LOUISIANA
POWER & LIGHT

W3K84-1454
Q-3-A35.02.01.02

Enclosed is the additional information you requested concerning the installation of Chicago Bridge & Iron piece numbers 55-2 welded to 55-4. This information also includes applicable attachments to nonconformance report # W3-6224.

Task: Allegation A-259

SUBJECT: INFORMATION REQUEST

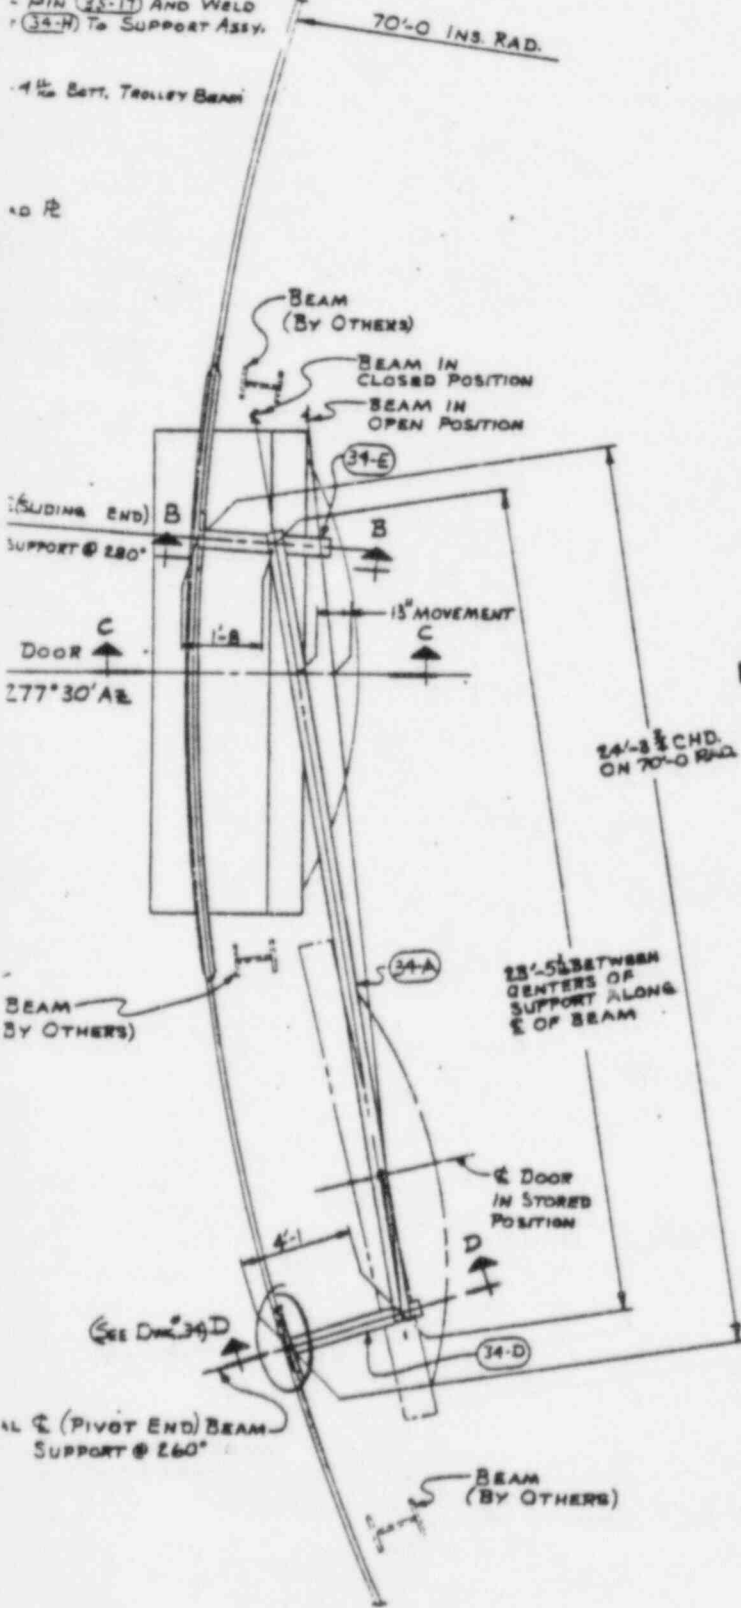
PLEASE PROVIDE DOCUMENTATION DEMONSTRATING TRACEABILITY OF THE WELD MATERIAL AND THE WELDER IDENTIFICATIONS AND CERTIFICATIONS FOR THE DISH TO CONTAINMENT SHELL WELDS (PART SS-3 TO THE CONTAINMENT SHELL) AND BEAM TO DISH WELD (PART SS-2 TO SS-3) IN CB&I DRAWING NO. 55 REV 7.

PROVIDE THE SAME INFORMATION FOR THE WELD BETWEEN PART 34-1 AND THE CONTAINMENT VESSEL ~~AND BETWEEN PARTS 34-24 AND 34-1~~ SHOWN IN CB&I DRAWING NO. 33 REV 3 AND BETWEEN PARTS 34-24 AND 34-1 IN CB&I DRAWING NO. 34 REV 4.
